<b>DOCKETED</b>	
<b>Docket Number:</b>	18-BSTD-02
<b>Project Title:</b>	2019 ENERGY CODE COMPLIANCE MANUALS
<b>TN #:</b>	224409
<b>Document Title:</b>	SEIA CALSSA Title 24 Energy Code Compliance Manual Comments
<b>Description:</b>	N/A
<b>Filer:</b>	System
<b>Organization:</b>	Evelyn Butler
<b>Submitter Role:</b>	Public
<b>Submission Date:</b>	8/3/2018 5:49:38 PM
<b>Docketed Date:</b>	8/6/2018

**SEIA CALSSA Title 24 Energy Code Compliance Manual Comments**

Re: Dockets 18-BSTD-02: 2019 Energy Code Compliance Manuals and Documents

**7.8 California Fire Code Solar Access Requirements**

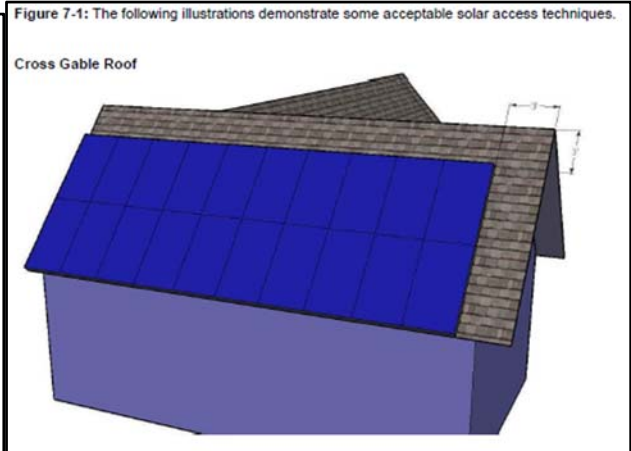
**2) Section 7.8 on page 7-13 for California Fire Code Solar Access Requirements**

The wording in this section has been deleted in this draft version of the chapter; however, the diagrams for rooftop access pathways and fire setbacks remain and should be updated as a result of the 2016 Intervening Code Cycle Supplement adoption into the 2016 California Codes. The requirements are in the 2016 California Residential Code for one- and two-family dwellings (pp. 111-112) and the 2016 California Fire Code (pp. 107-109) for commercial and multi-family buildings. Further, the diagrams should either be moved into Section 7.8 Solar Zone or retained as a new section

7.9 with the original title (thus requiring renumbering of subsequent sections if the current section order is retained).
